PRAIRIE ISLAND NUCLEAR GENERATING PLANT
ANNUAL REPORT OF OCCUPATIONAL EXPOSURE - 1978

PRAIRIE ISLAND NUCLEAR GENERATING PLANT
ANNUAL REPORT OF CHANGES, TESTS, AND EXPERIMENTS

The following changes, tests or experiments have been completed under the provisions of 10 CFR 50.59(a)(1):

FIGURE 1
CORE LOADING PATTERN
PRAIRIE ISLAND UNIT 1, CYCLE 4

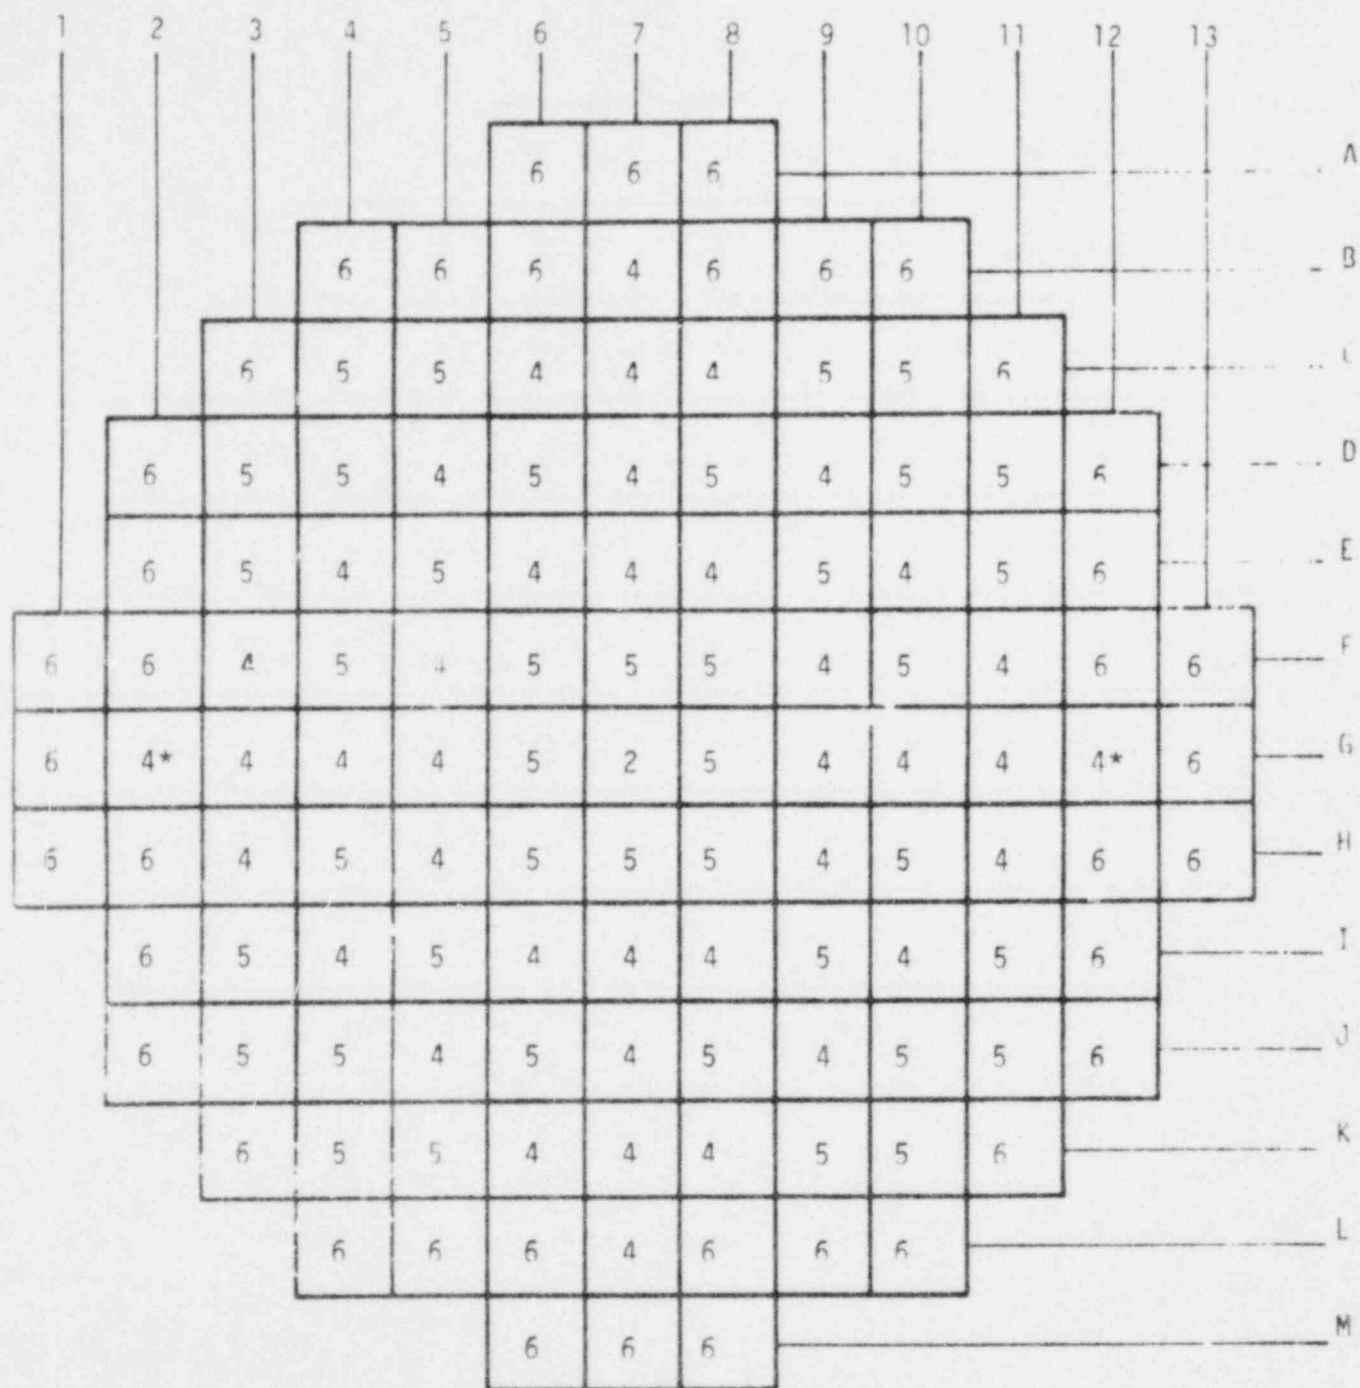
1. Unit 1, Cycle 4 Reload (Design Change 78L443)

The safety evaluation for Unit 1, Cycle 4 demonstrated that the core reload will not adversely affect the safety of the plant.

For Cycle 4 operation, Prairie Island Unit 1 replaced 40 region 6 assemblies and one region 2 assembly. The core pattern for Cycle 4 is shown in Figure 1. All of the accidents analyzed and reported in the FSAR which could potentially be affected by fuel reload have been reviewed for the Cycle 4 design. No changes in the Technical Specifications are required to accommodate the Cycle 4 design. Nominal design parameters for Cycle 4 are 1650 MWT core power, 2250 psia system pressure, nominal inlet core temperature of 531°F and core average linear power of 6.2 KW/FT. The fuel assembly design parameters are presented in Table 1.

FIGURE 2
CORE LOADING PATTERN
Prairie Island Unit 2, Cycle 4

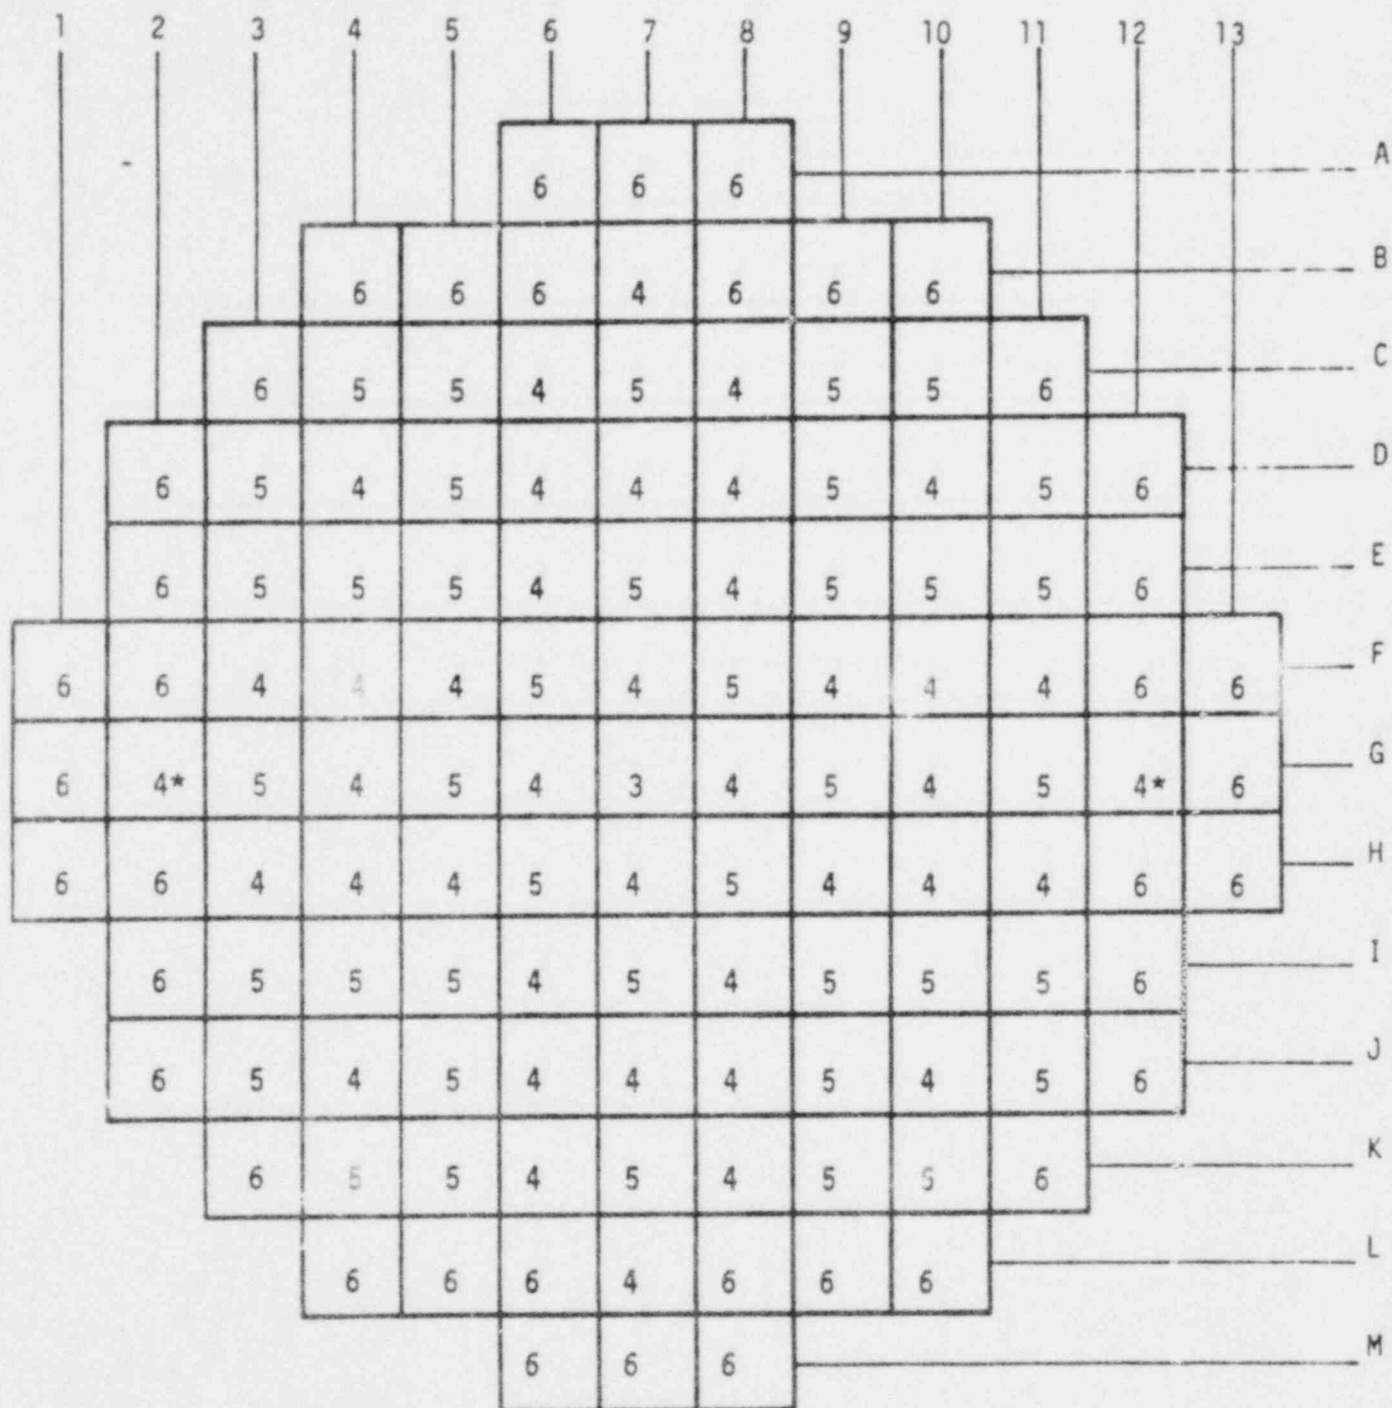
1. Unit 2, Cycle 4 Reload (Design Change 78L499)

The safety evaluation for Unit 2, Cycle 4 demonstrated that the core reload will not adversely affect the safety of the plant.

For Cycle 4 operation, Prairie Island Unit 2 replaced 40 region 6 assemblies. The core pattern for Cycle 4 is shown in Figure 2. All of the accidents analyzed and reported in the FSAR which could potentially be affected by fuel reload have been reviewed for the Cycle 4 design. No changes in the Technical Specifications are required to accommodate the Cycle 4 design. Nominal design parameters for Cycle 4 are 1650 MWT core power, 2250 psia system pressure, nominal inlet core temperature of 531°F and core average linear power of 6.2 KW/FT. The fuel assembly design parameters are presented in Table 2.
